Modification Changes
- Addition of louvers to podium of the mezzanine level and level 1
- Airlock reconfiguration

Project
WATERLOO METRO QUARTER DEVELOPMENT

Sheet title
General Arrangement Plan
Roof Plan

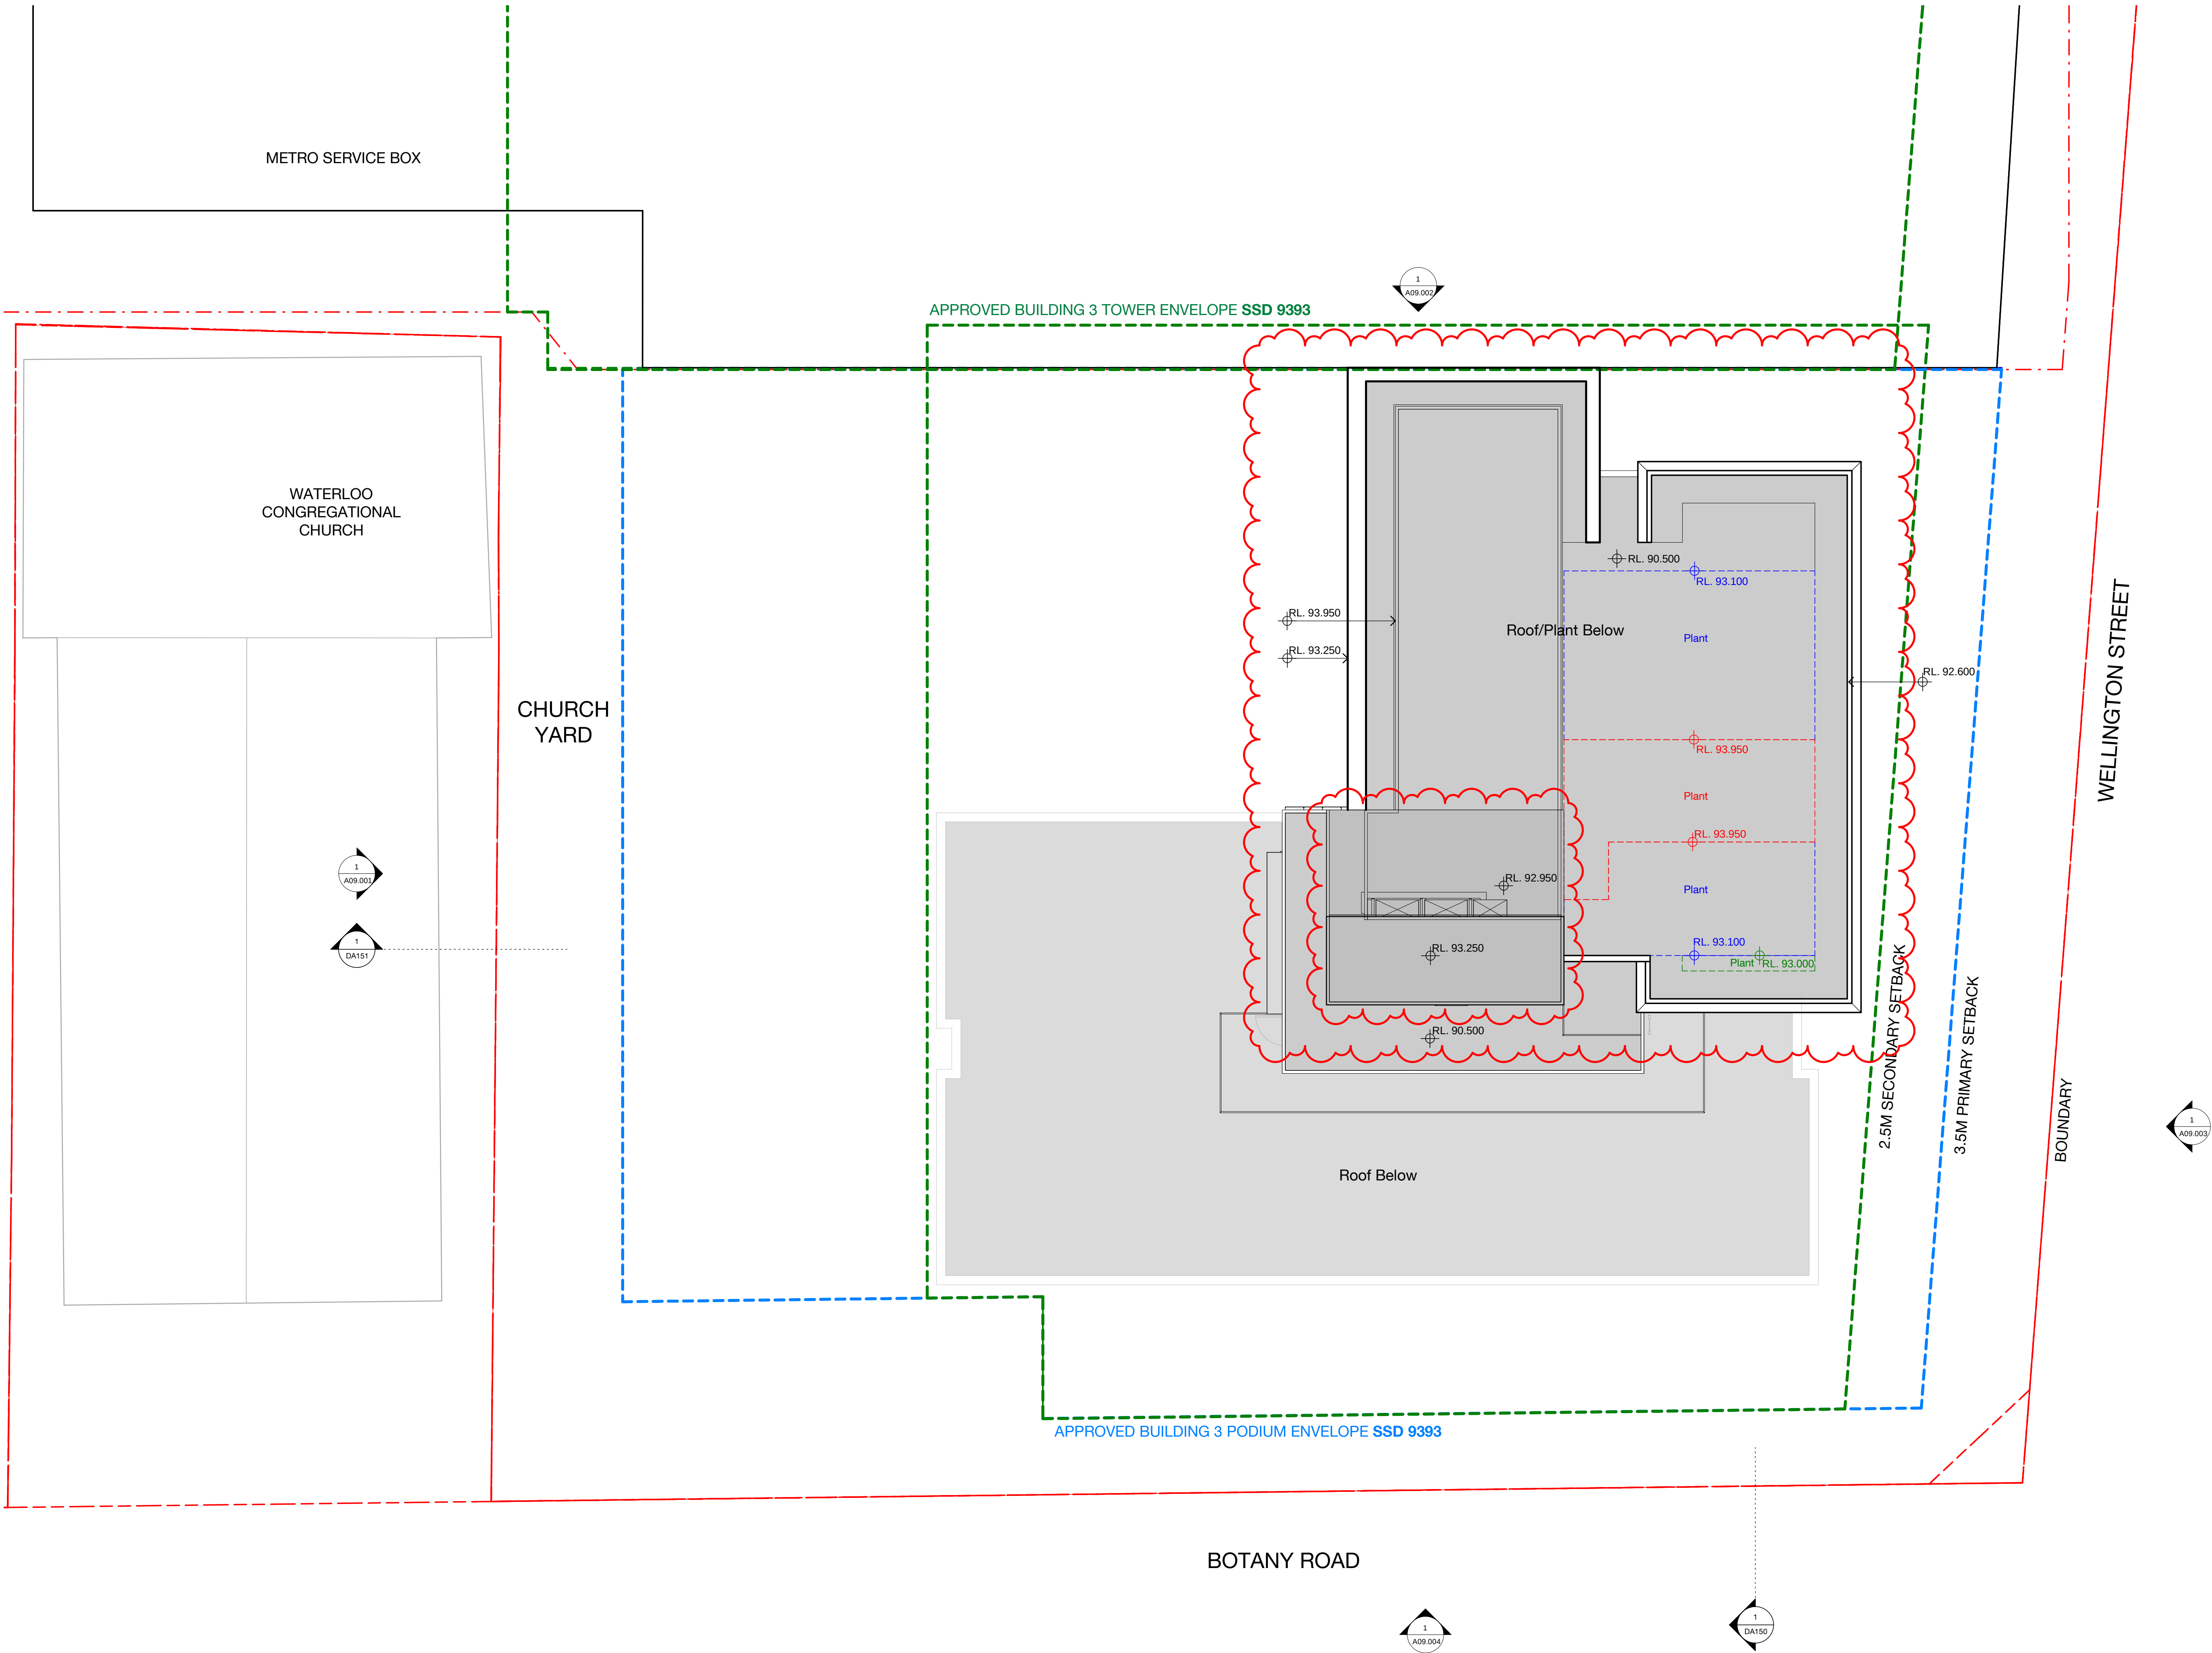
- Modification Changes
- Student Accommodation - reconfiguration to the core and services
 - Roof plant zone

Elevation - North

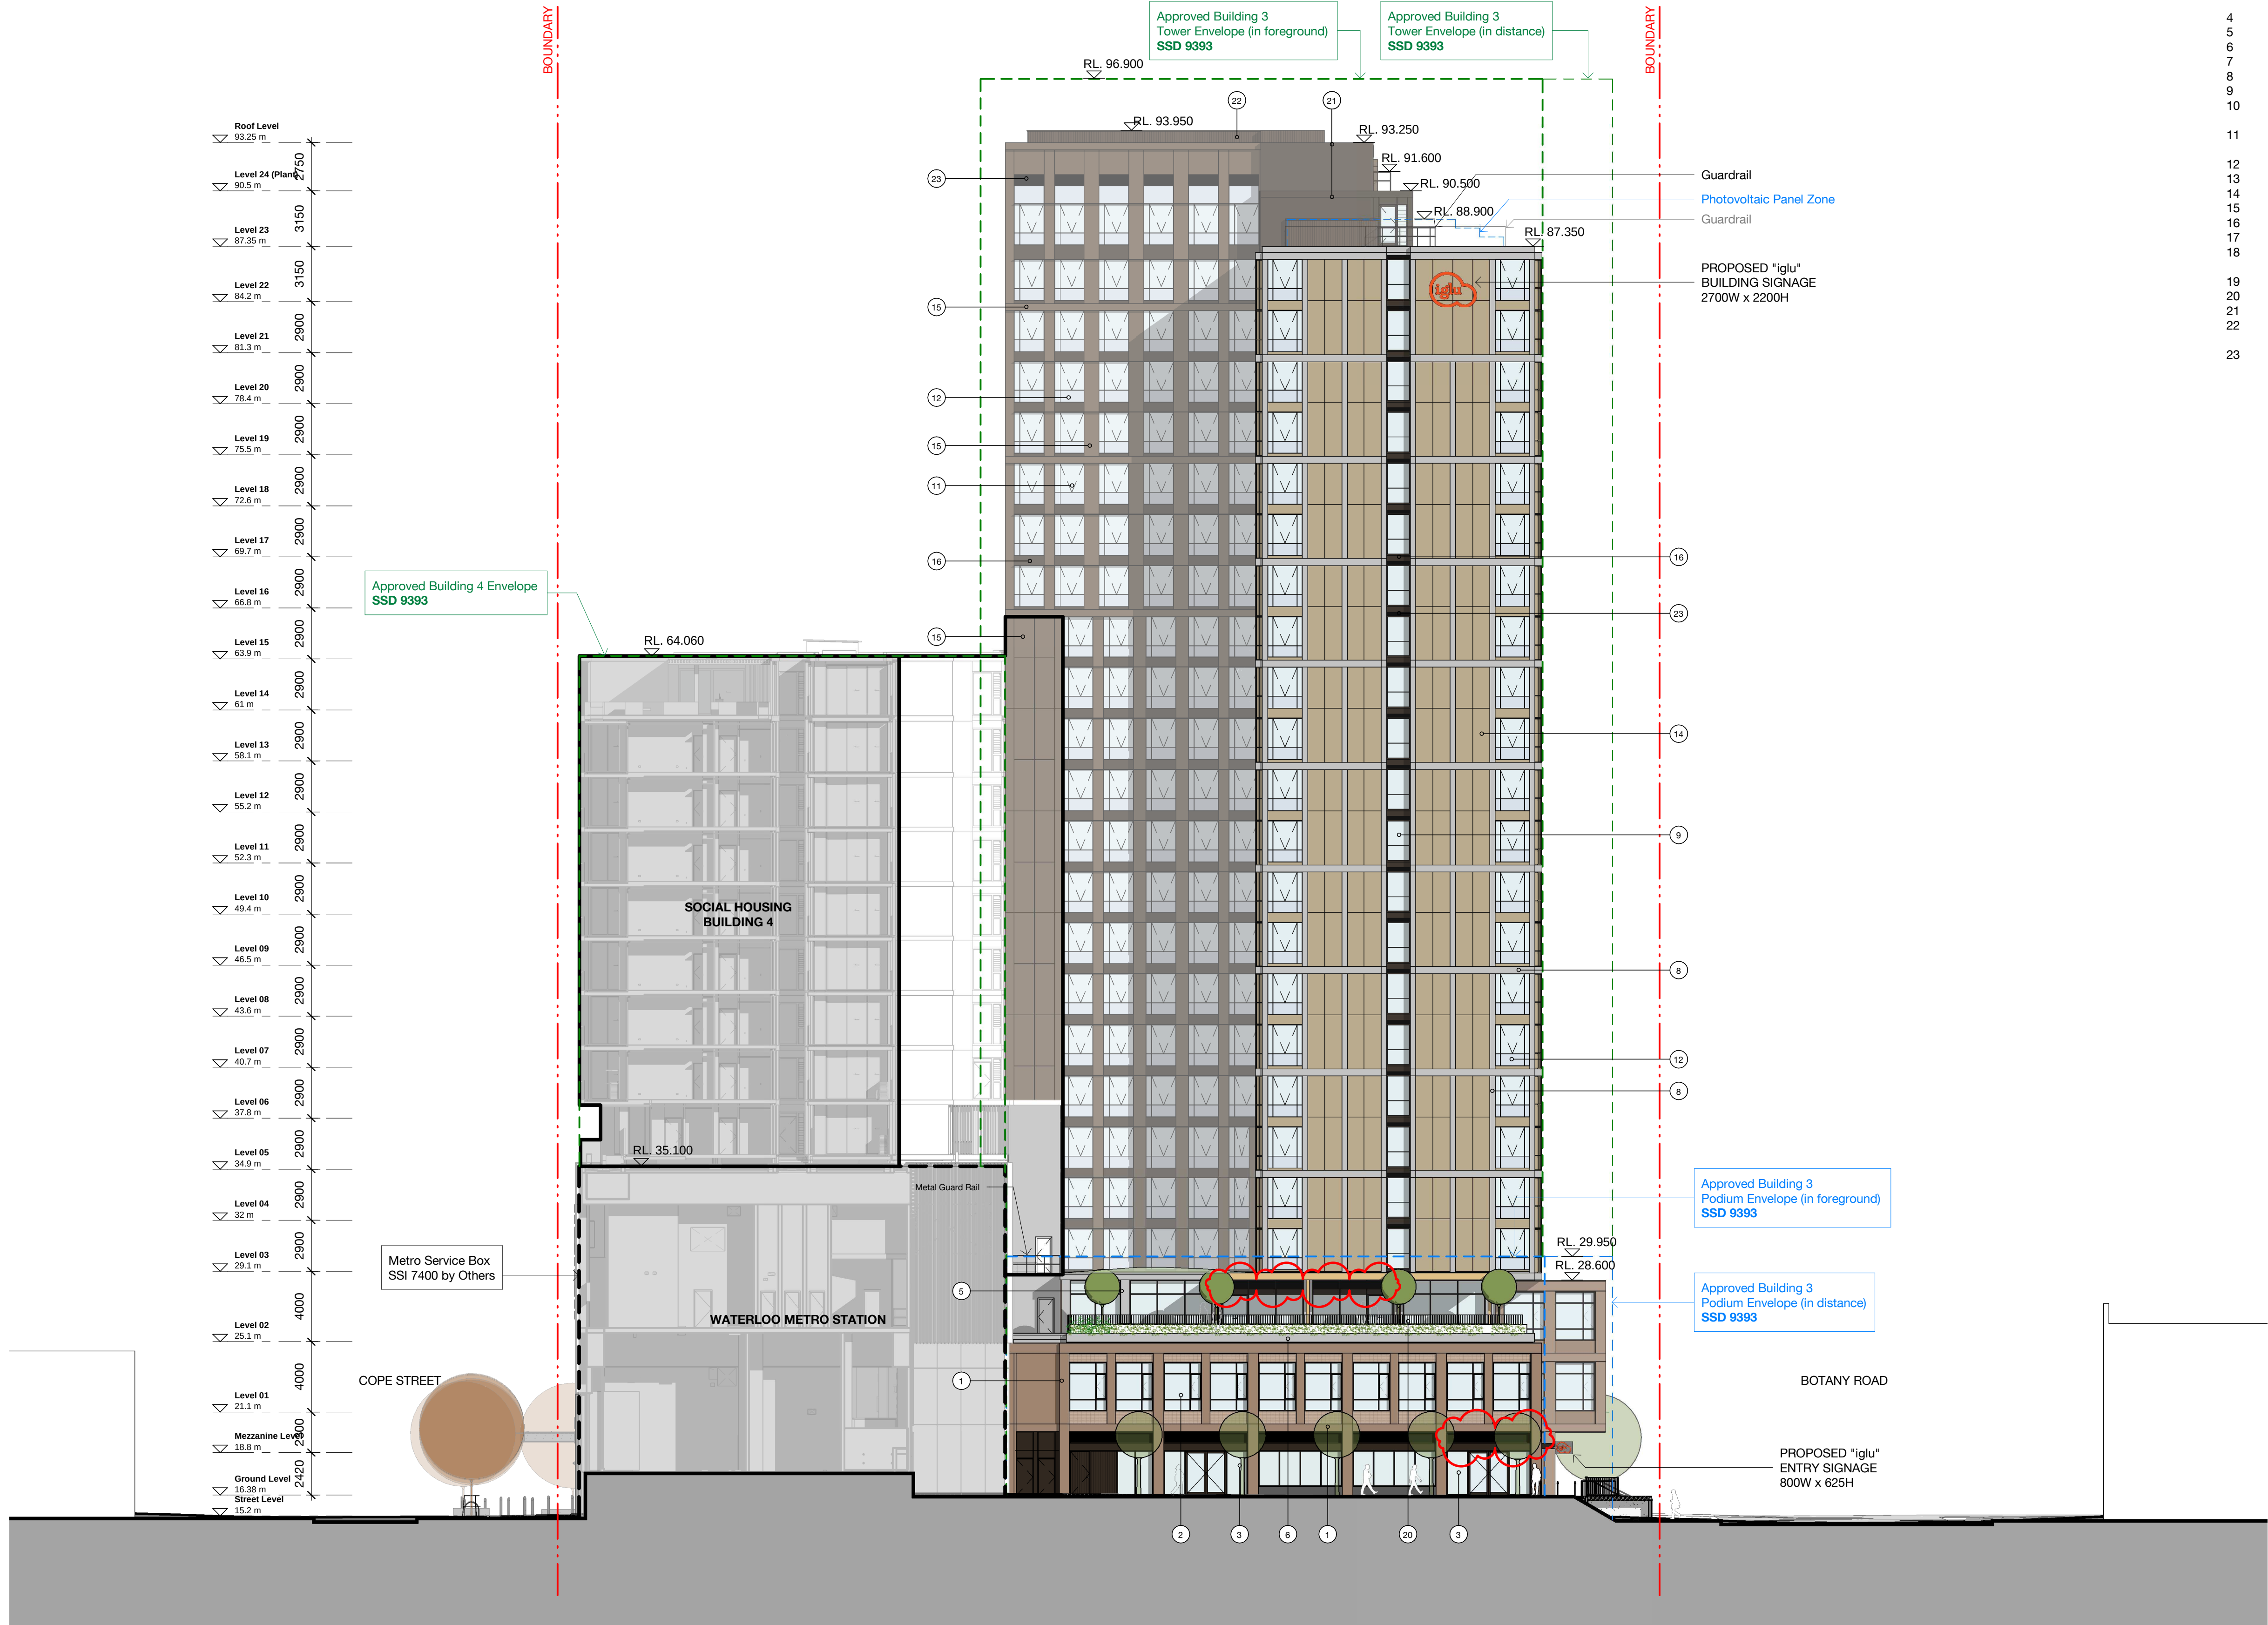
- Addition of louvres to the ground level and level 2

Elevation - West

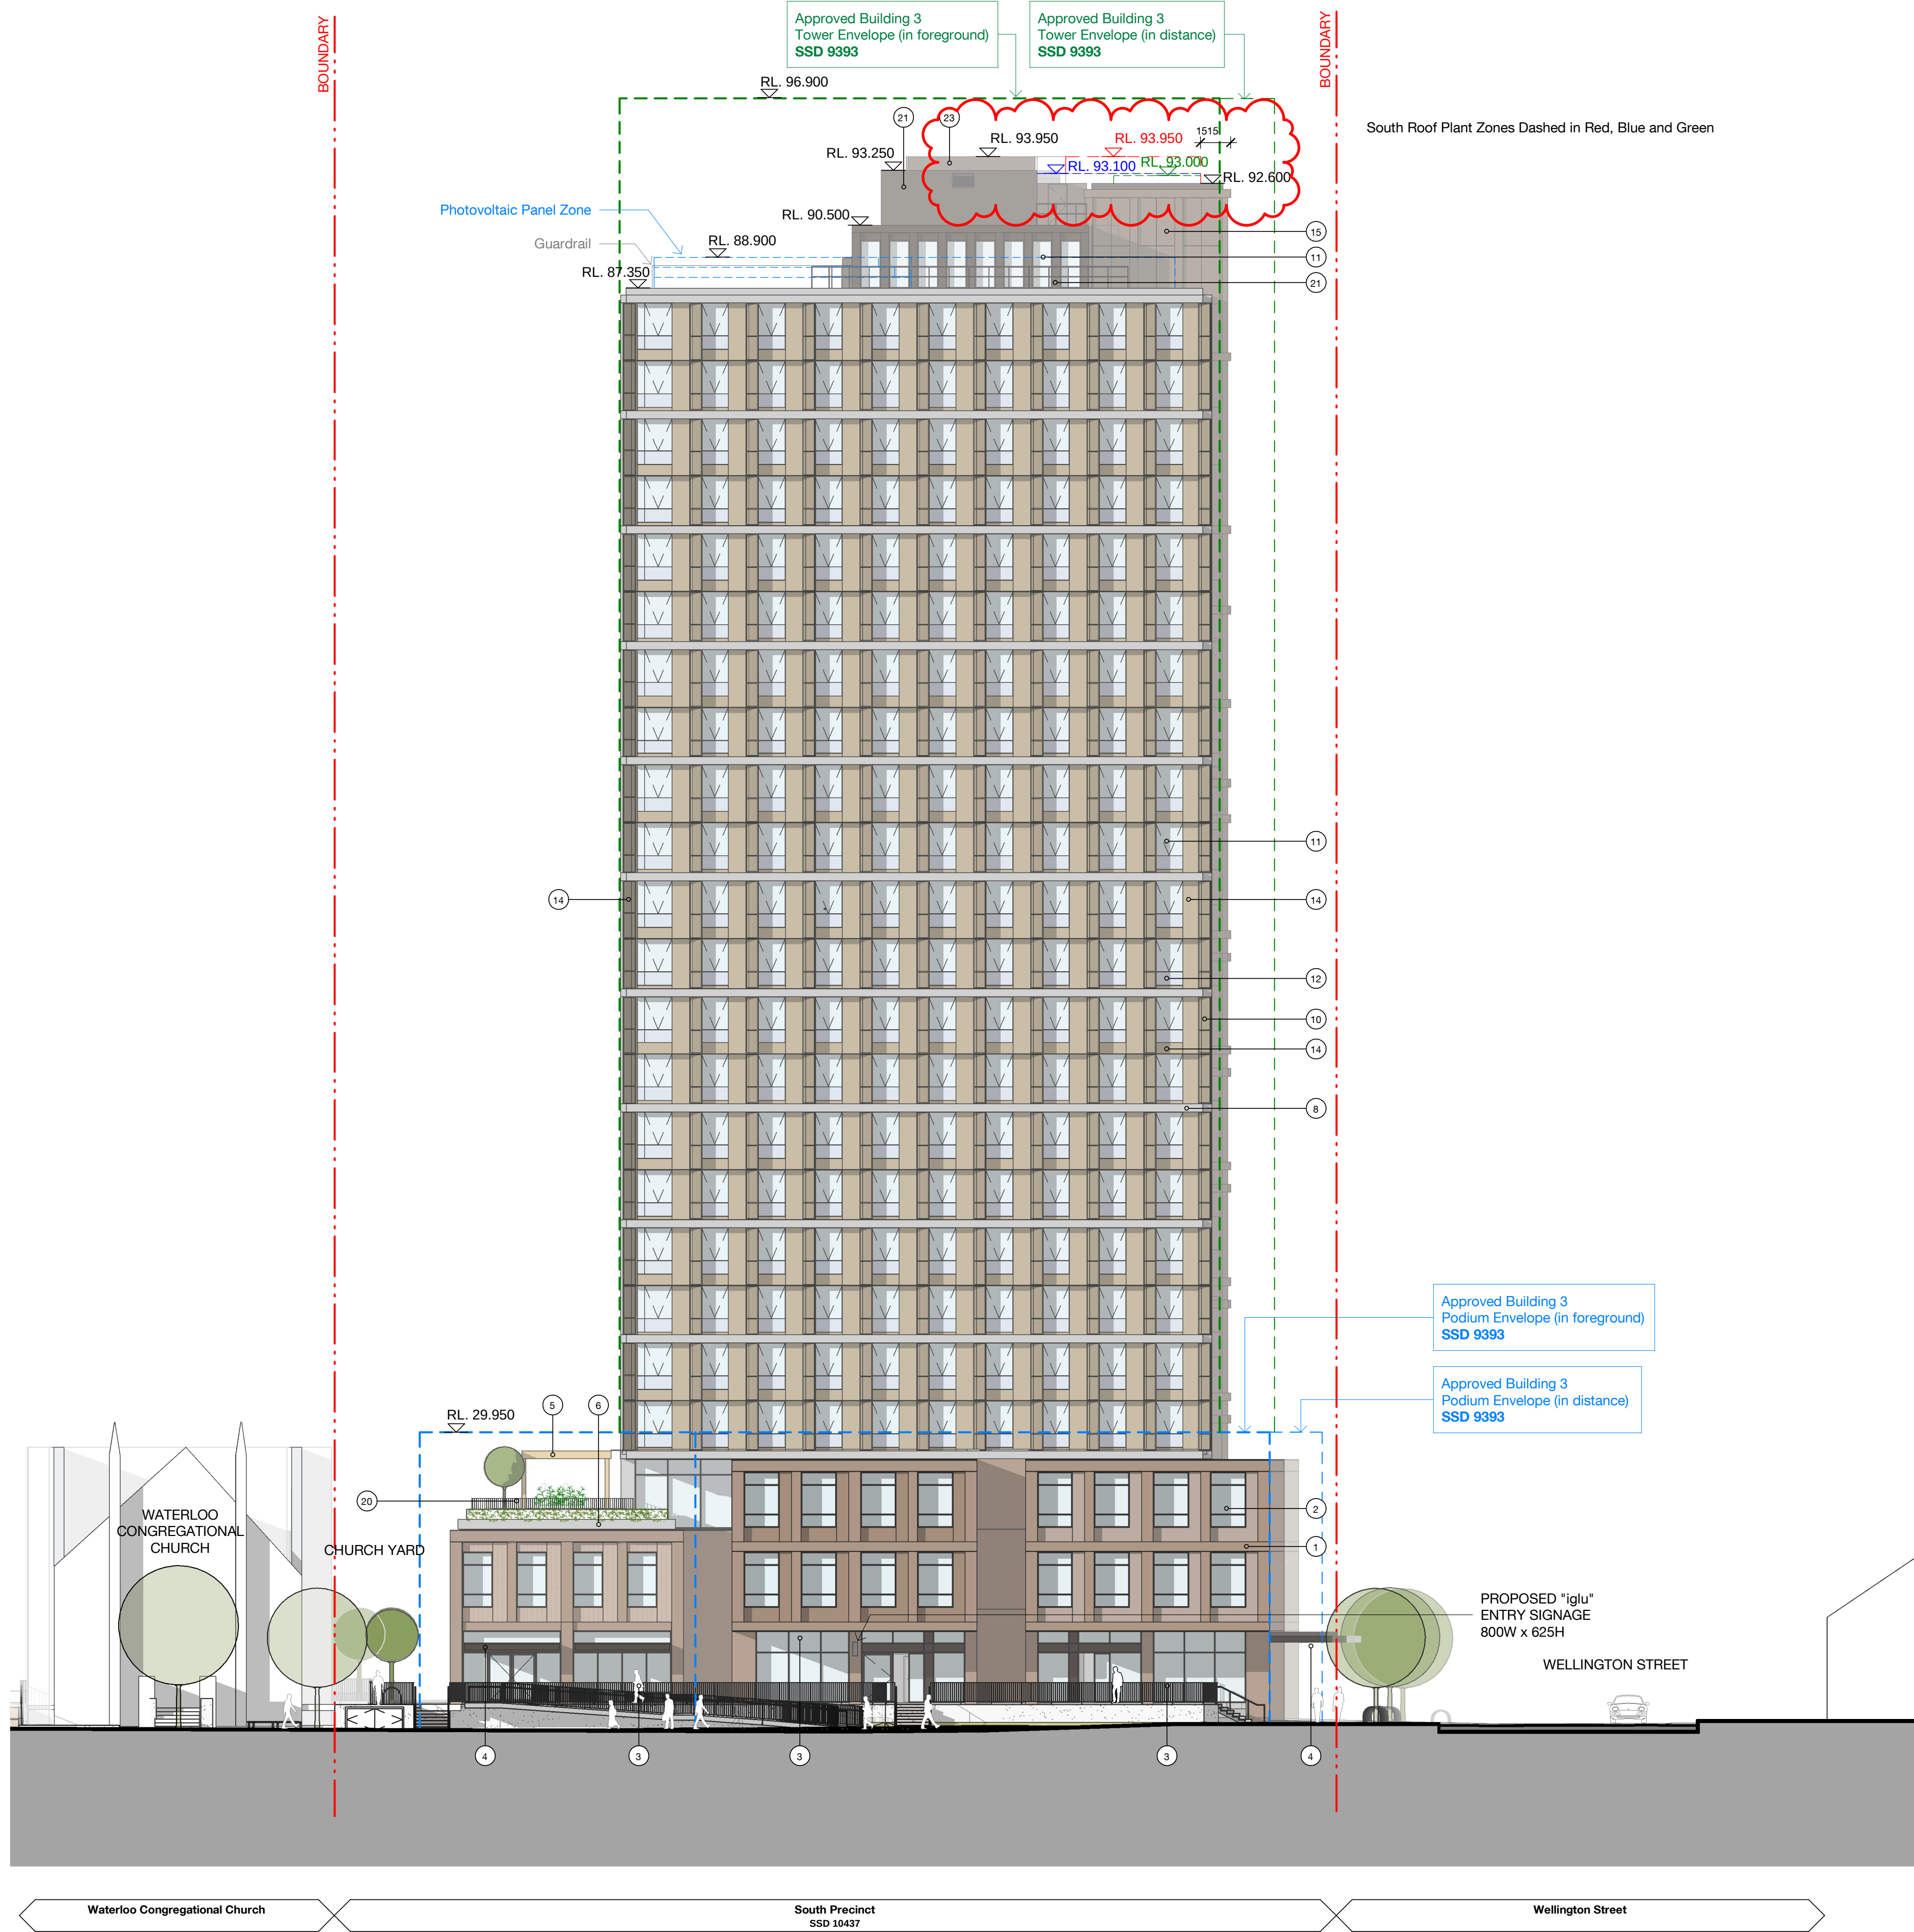
- Roof plant zone
- Addition of louvre to level 24 lift core
